CONTENTS

No. 41

**RUMBOLD SAFETY BELTS, TYPE M.192 (ISSUE 4)
AND M.368 (ISSUE 3)**

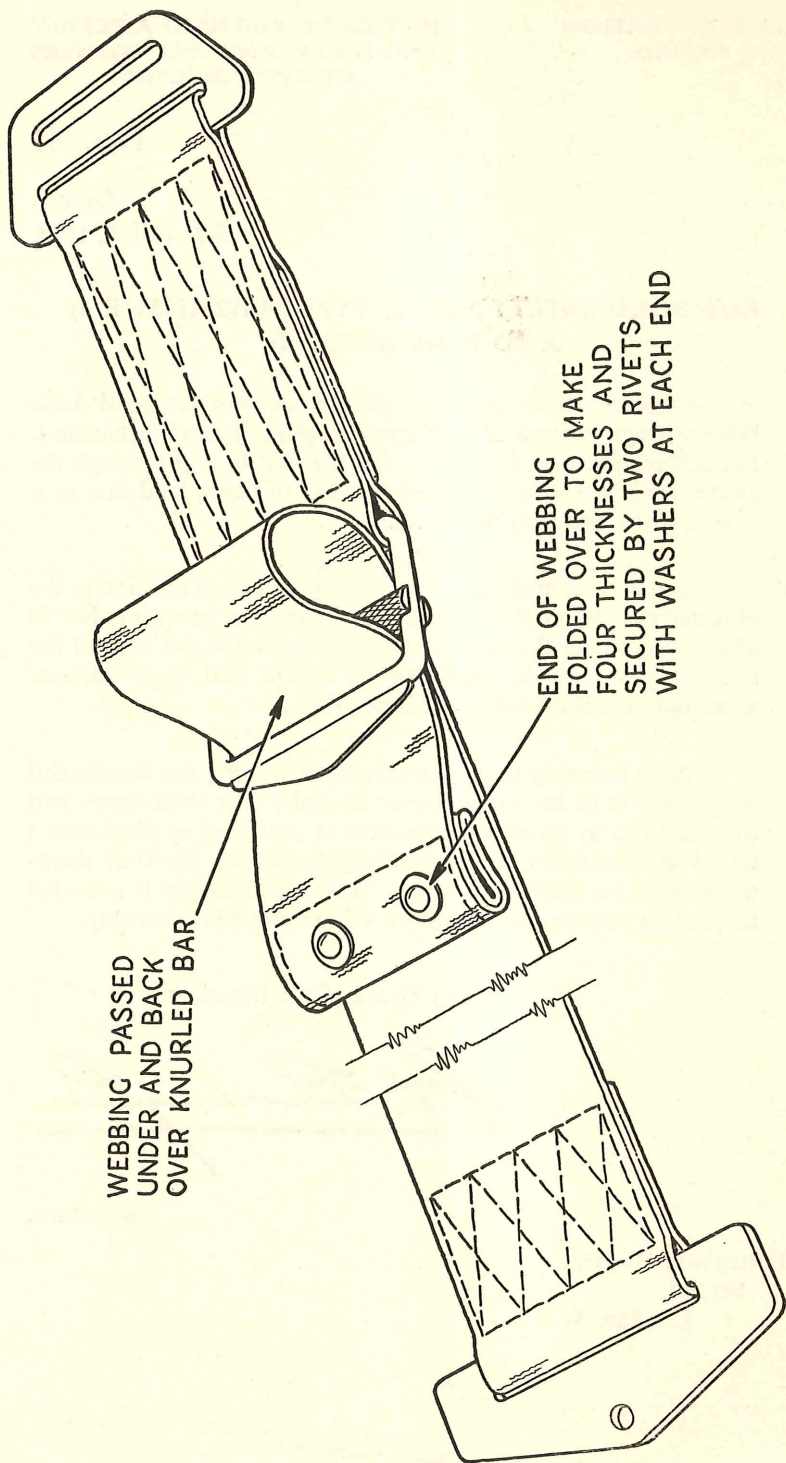
- 1** Instances have occurred of the above-mentioned belts being wrongly assembled in relation to their adjuster mechanisms. In such instances, it is possible for the belt to slip through the adjuster when a load is applied, instead of being held fast as it will be if the assembly is correct.

- 2** The correct method of assembling the belt in relation to the adjuster is illustrated overleaf. As early as convenient, but in any case not later than the next minor inspection, all belts of the above types must be inspected to ensure that their adjuster assemblies conform with this illustration.

- 3** After ensuring that the assembly is correct, the tongue end of the belt is to be doubled over to make four thicknesses and then secured by rivets with washers at each end as illustrated; or, as an alternative to the rivets and washers, the four thicknesses may be stitched together. This modification is intended to prevent subsequent alteration of the adjuster assembly.

WEBBING PASSED
UNDER AND BACK
OVER KNURLED BAR

END OF WEBBING
FOLDED OVER TO MAKE
FOUR THICKNESSES AND
SECURED BY TWO RIVETS
WITH WASHERS AT EACH END

FIGURE 1

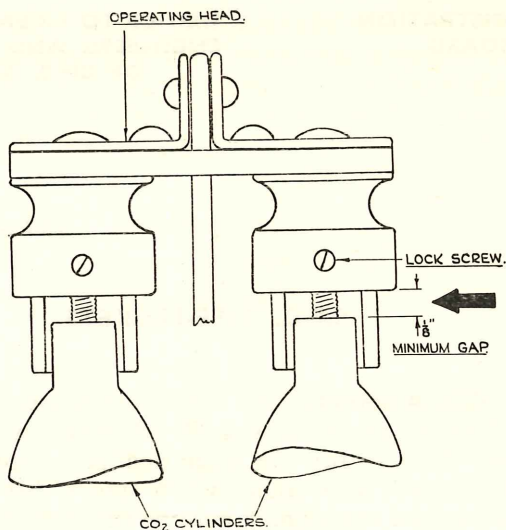
1.1 Remove the CO₂ assembly from the jacket and check the clearance between the bottle-neck and holder, as illustrated in Figure 1, overleaf.

1.2 Check that the lock screw is only sufficiently tight to prevent rotation of the bottle.

FIGURE 2

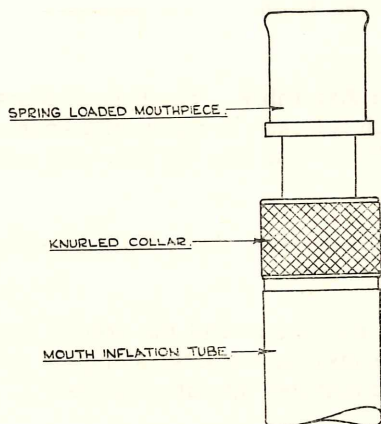
2 **Mouth Inflation Assembly** The Type 47 Mark 2 has a metal mouthpiece which is locked by means of a knurled collar. To facilitate the use of this assembly the following action is to be taken forthwith.

2.1 Tighten the knurled collar down fully to the position shown in Figure 2, overleaf.

2.2 As a temporary measure amend the printed instructions (using a copper-free ink) on the label alongside the mouth inflation assembly so that they appear as follows :—

FOR TOPPING UP

██████████ PUSH DOWN
VALVE WITH MOUTH
██
